# UNITED STATES PATENT AND TRADEMARK OFFICE

10/560,148

Ulrich Bantle

**Office Action Summary**

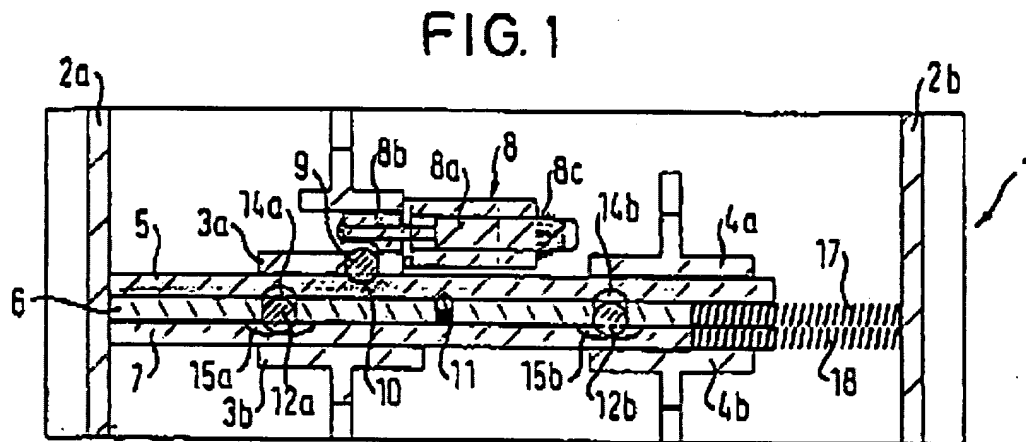
13. Regarding claims 4 and 12, Engler in view of Goldman, Goldman shows the shield as applied to claim 1 above but fails to mention the thickness of the material. The claimed thickness of "at least 0.8mm" is considered mere design choice. It would be

obvious to one of ordinary skill in the art to make the shielding element greater than 0.8mm in order to provide a structure strong enough to protect the magnet.

Engler

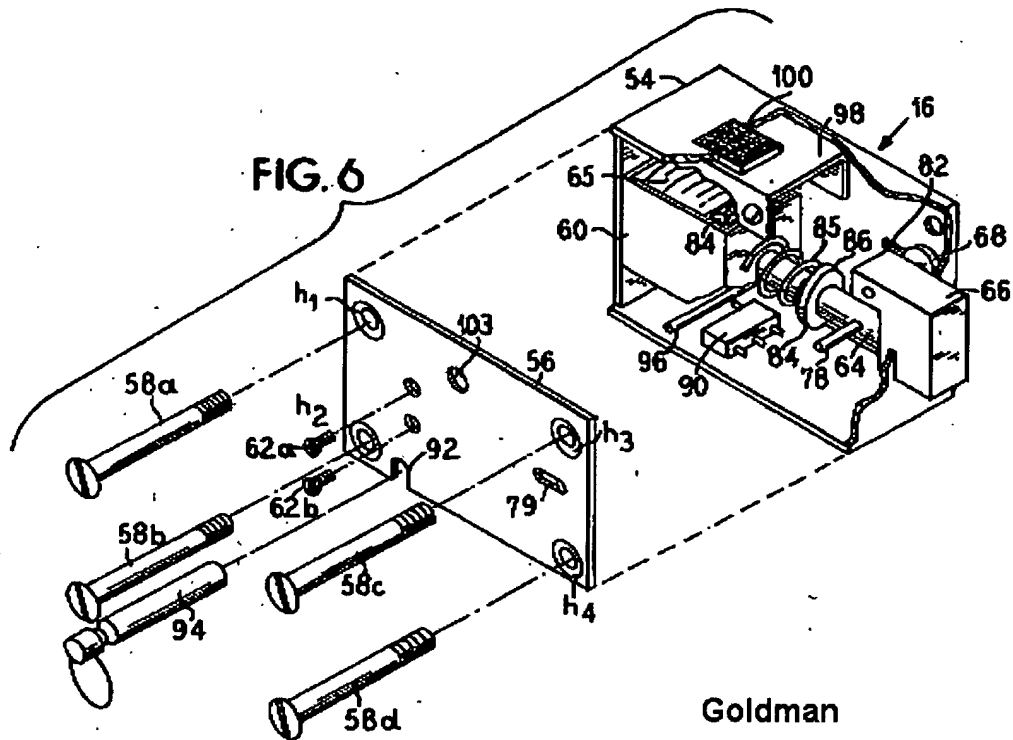
magnet (65), the lock comprising a control device (control unit, 18) which can be adjusted by a keypad (38) assigned to the magnet in which code information is storable which in case of renewed input and after being checked by the stored code information is used for controlling the magnet. Although Goldman does not specifically point out that the locking system includes a control knob, he includes that it is to be used on an apartment door (column 2, lines 60-64). It is well know in the art that an apartment door includes a control knob for operating a bolt. See the Engler and Goldman devices below.
